From: [Norman Huff](#)
To: [FCGMA](#)
Subject: Comments on the First Periodic Evaluation, Groundwater Sustainability Plan for the PVB
Date: Monday, October 7, 2024 1:54:10 PM
Attachments: [20241007 SUBMITTED CWD COMMENTS ON PVBGSP EVAL.pdf](#)

Re: Comments on the “First Periodic Evaluation, Groundwater Sustainability Plan for the Pleasant Valley Basin”

**COMMENTS ON “FIRST PERIODIC EVALUATION, GROUNDWATER SUSTAINABILITY PLAN
FOR THE PLEASANT VALLEY BASIN” DATED August 2024**

Attachment A
Comparison of UWCD Calibrated Models
Original Ventura Regional Groundwater
Flow Model (1985-2015) and Coastal Plain
Model (1985-Sep 2022)

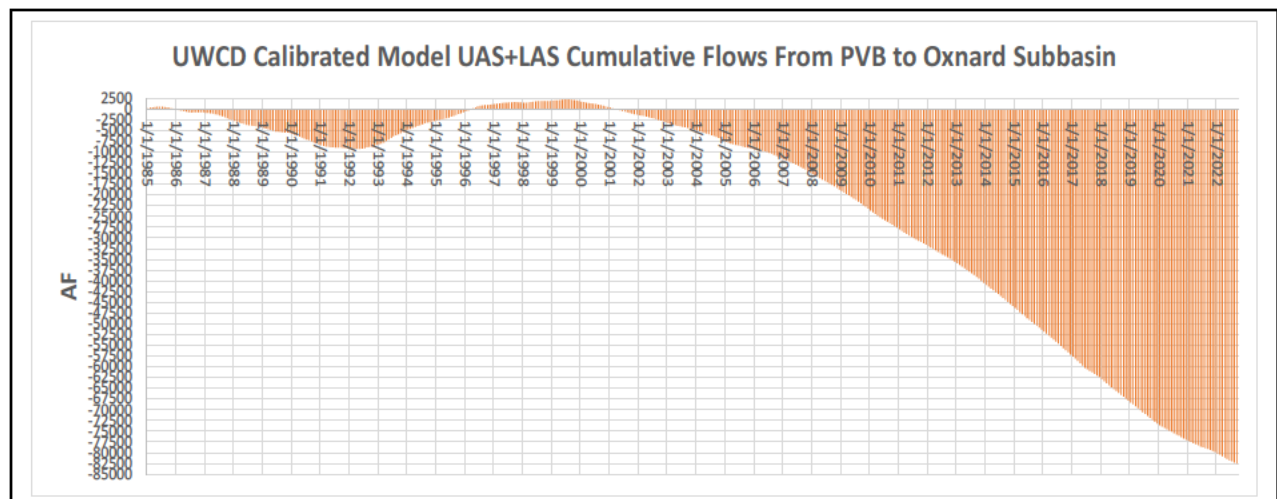
p. ES-2, Section “Current Groundwater Conditions.” The statement that “Groundwater production for agricultural, municipal and industrial use in the PVB, specifically near the boundary with the Oxnard Subbasin, has contributed to seawater intrusion in both the UAS and LAS of the Oxnard Subbasin (FCGMA, 2019)” has not been demonstrated. In fact, the UWCD calibrated model (covering 37.75 years) used for the GSP and updated through September 2022 shows that an average of approximately 5,430 AFY of groundwater flow occurred from the PVB to the Oxnard Subbasin. This is about 22 percent of the total average annual recharge to the PVB over the calibration period. Following is a plot showing the flow from PVB to Oxnard Subbasin by aquifer over the 1985 to 2022 period.

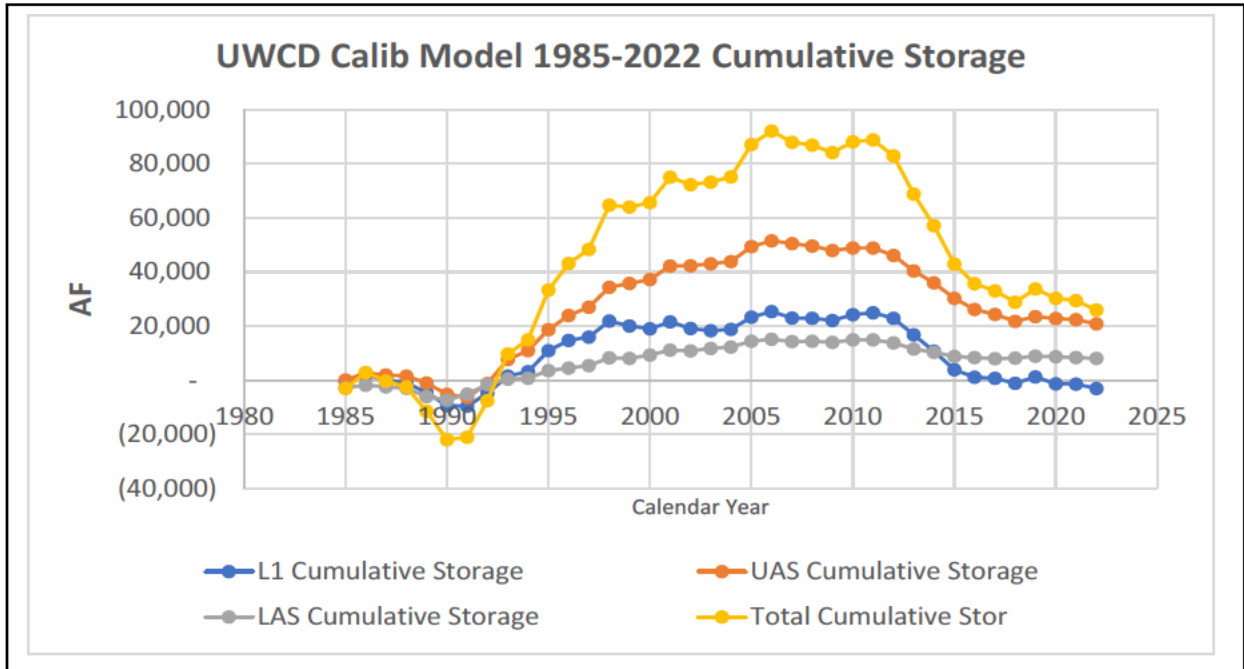
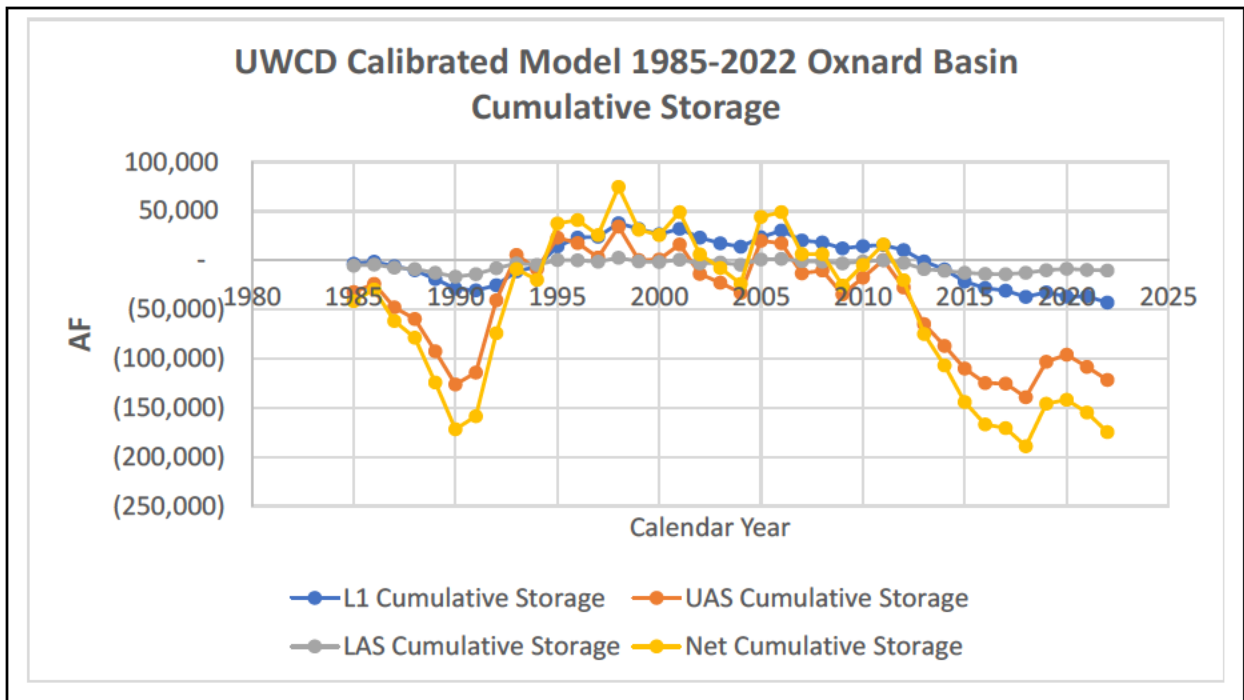
UWCD’s calibrated groundwater flow model also shows that, with minor exceptions from about 1996 to 2001, there was a surplus of cumulative flows from the UAS+LAS aquifers in the PVB to Oxnard Subbasin such that the cumulative flow from PVB to the Oxnard Subbasin totals about 83,000 AF in those two aquifer systems. See plot below.

This section should acknowledge that, on average, the Oxnard Subbasin is in a state of critical overdraft, where sources of recharge are insufficient to support average annual groundwater discharges, including pumping, from the Subbasin, and that mostly, groundwater flow is from the PVB to the Oxnard Subbasin. During wet periods, pumping in the Oxnard Subbasin is reduced somewhat and the Subbasin's groundwater is recharged, increasing groundwater levels, which results in reductions in groundwater flow from the PVB to the Oxnard Subbasin. There is no demonstration that groundwater pumping in the PVB contributed to seawater intrusion in the Oxnard Subbasin. In fact, the UWCD calibrated groundwater model results show that cumulative storage of the PVB is nearly always positive, especially in the UAS and LAS aquifers, as shown in the following plot.

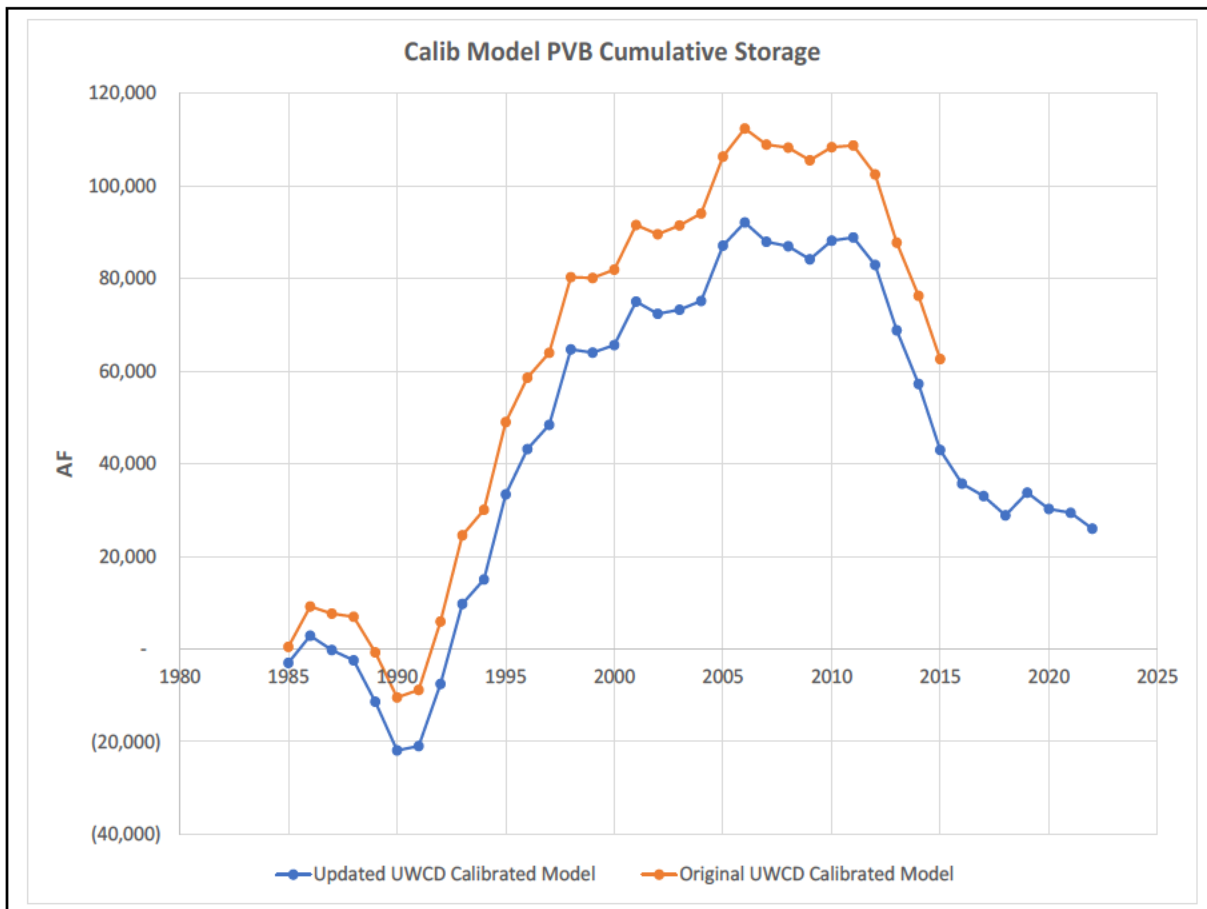
p. ES-4, second para. The first sentence of this paragraph states that under Future Baseline conditions, groundwater production is anticipated to exceed the Sustainable Yield by approximately 1,200 AFY. However, the cumulative storage of the PVB shows an overall increase in net storage over the water years 2022 through 2069 simulative period as shown in the plot below. The average pumping over the 2022-2069 period is 14,557 AFY.

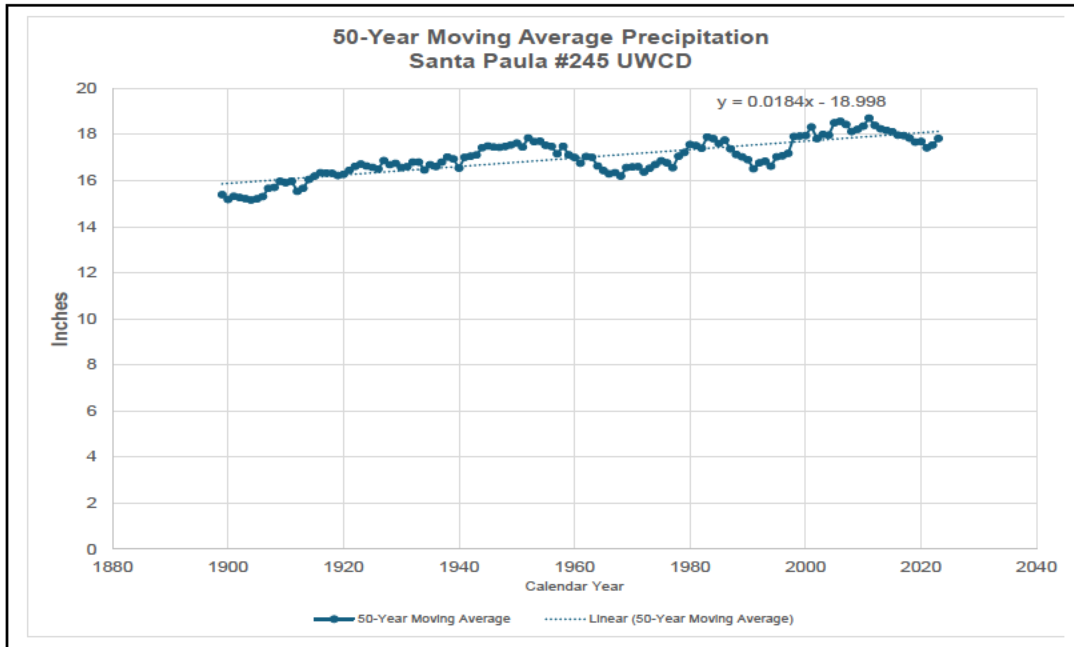
However, data provided by UWCD staff show that prior to 1890, only annual values are provided and monthly values are provided for all years 1890 and onward. We plotted the 50-year moving annual average value of precipitation for this station as shown in the plot below. This analysis shows that mean precipitation has been trending upward by nearly 2.5 inches since 1900, indicating increasingly wetter hydrology, which is consistent with a slightly warming climate. Therefore, we suggest that using the full 1850 to 2023 average is not representative of the more recent average, and that the long-term average should be limited to 1890 to 2023. The long-term mean precipitation for this period is 17.2 inches.

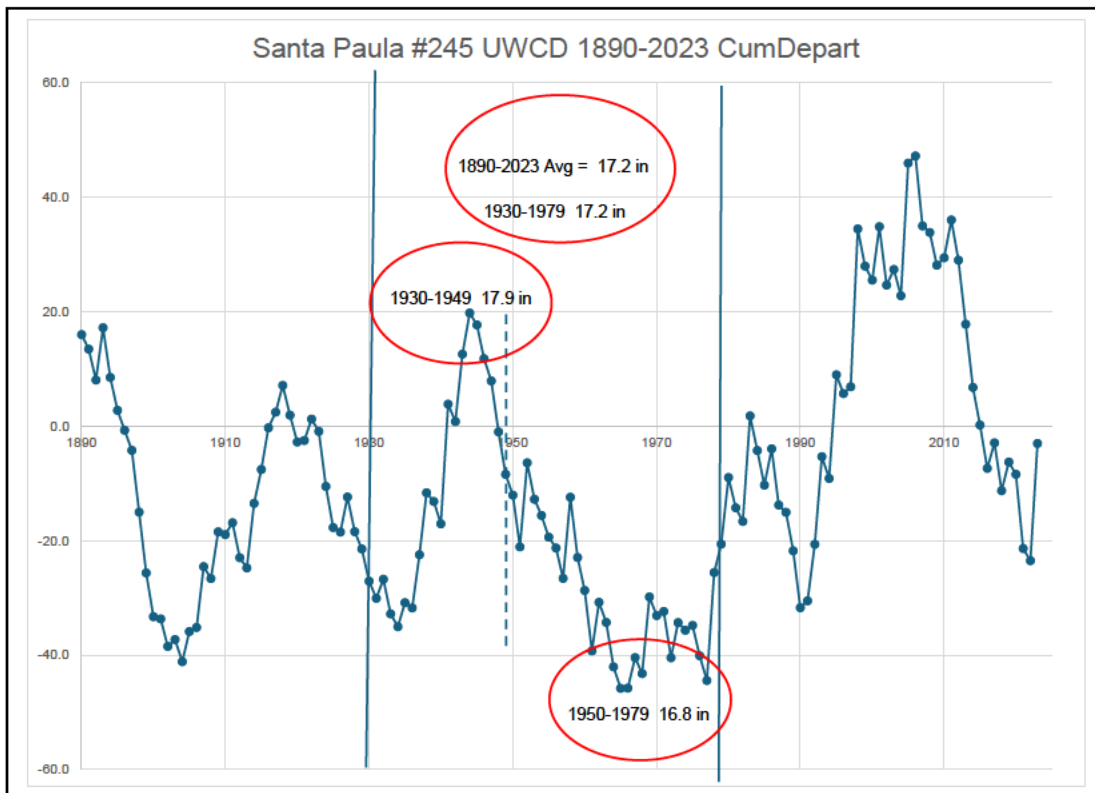
The plot below shows the cumulative departure from mean precipitation for the period 1890 through 2023.

As shown in this plot, the 1930 through 1979 mean precipitation is 17.2 inches, the same as the 1890 through 2023 average. The first 20 years of this period is wetter than the last 30 years, 17.9 inches versus 16.8 inches. These differences may appear small, but they are significant, especially as runoff to streams is higher for higher precipitation events. For example, UWCD estimates recharge diverted to spreading basins in the Oxnard Forebay is greater than 2,200 AFY more for the period 2022 through 2039 compared to the period 2040 through 2069.

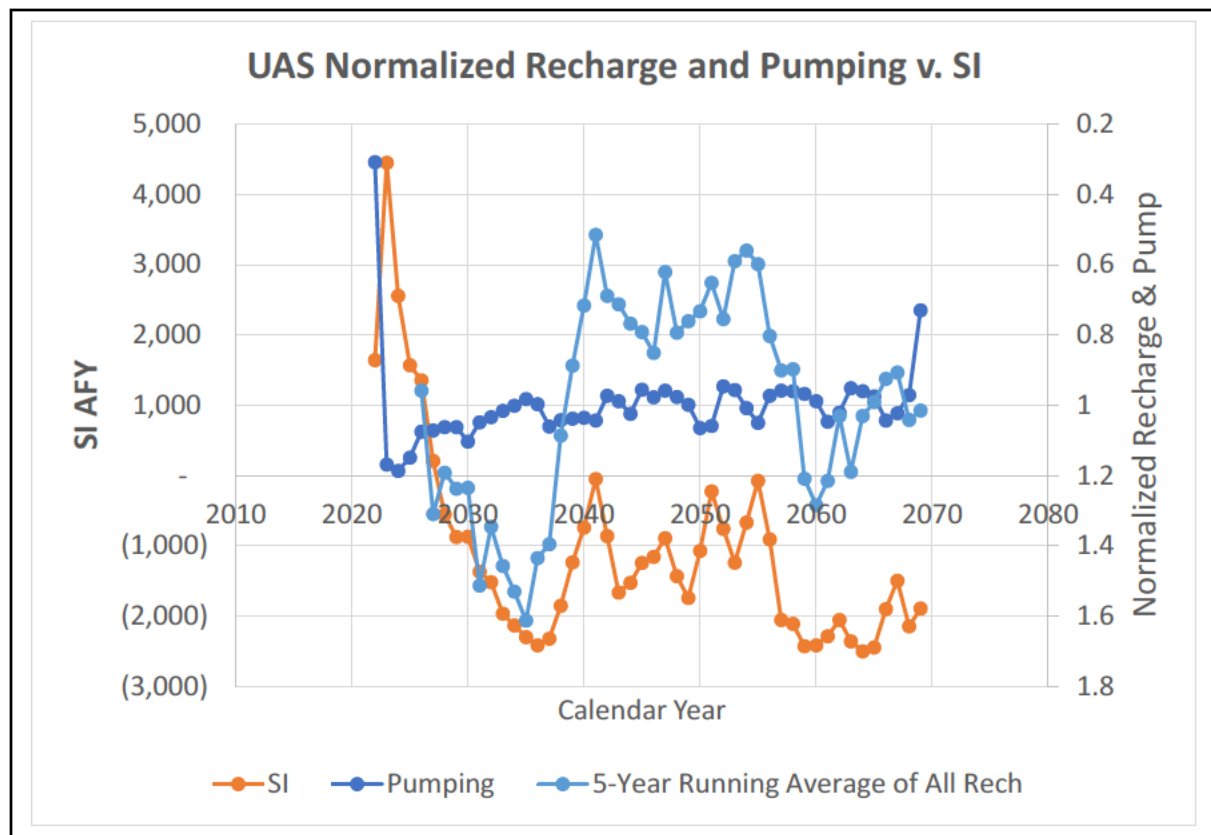
3. Use of the period 2022 through 2039 for the “implementation period” to ramp down pumping is completely arbitrary. It is unknown as to what the actual hydrology is going to be in the future. It just so happens that 1933 through 1950 (projected to 2023 through 2040) is a wet period as described above. This wet period helps dampen the impacts of pumping on seawater intrusion during the ramp down of pumping. The significance of this wet period recharge is shown by plotting normalized values of recharge and pumping against seawater intrusion (SI, i.e., coastal inflow of groundwater) in the Oxnard Basin in Scenario NNP2 below.

This plot shows a rapid decline in seawater intrusion in the UAS in response to the much higher-than-average recharge in the implementation period. Average values of recharge are values that equal the average recharge over the full 47 years. A 5-year moving average recharge value is plotted to smooth the spikes in individual years. So, a value of normalized recharge equal to the average is 1, whereas values greater than 1 indicate higher than average recharge, and values lower than 1 indicate lower than average recharge. A plot of normalized pumping is also shown using the same process used to compute normalized recharge. It is clear from this plot, recharge is significantly above average in the 10 to 12 years of the implementation period, which results in a substantial decline in seawater intrusion rates in the implementation period. However, as stated above, the future is unknown, so it is not knowable as to what the actual trend will be in the future.

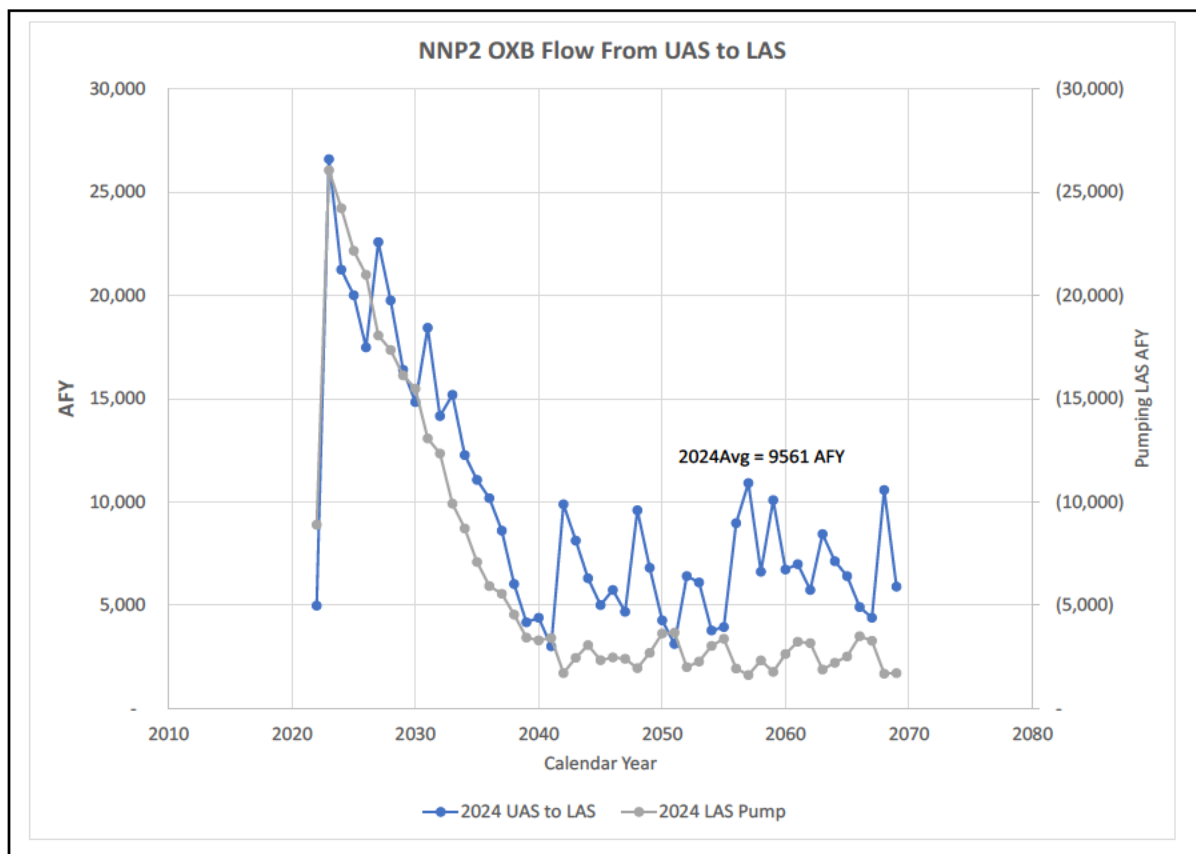
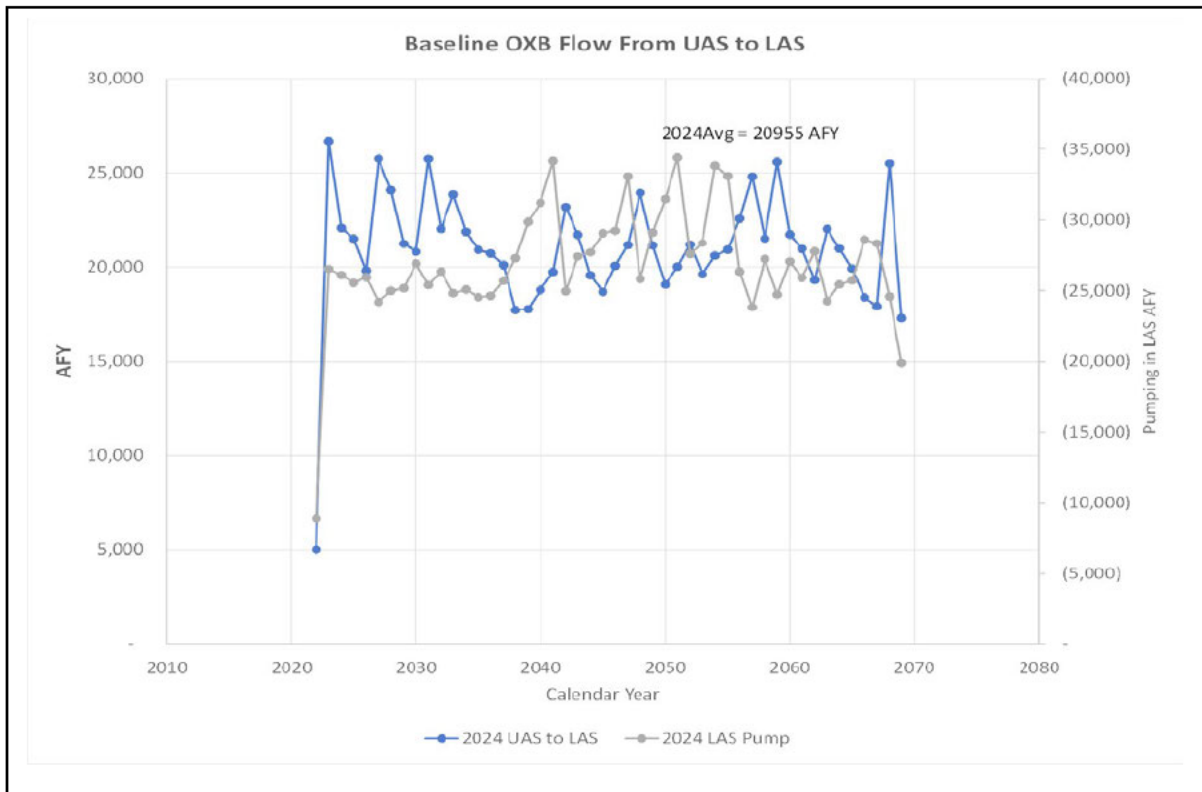
1. Groundwater flow between Layer 1 (L1) and the UAS in the Oxnard Subbasin is reversed as shown in the two plots below. In the Future Baseline scenario groundwater flow is predominantly from L1 to the UAS and averages about 3990 AFY. In the NNP2 scenario, groundwater flows predominantly from the UAS to L1, averaging about 5,620 AFY. This represents a 9,610 AFY reversal in flow between L1 and the UAS.
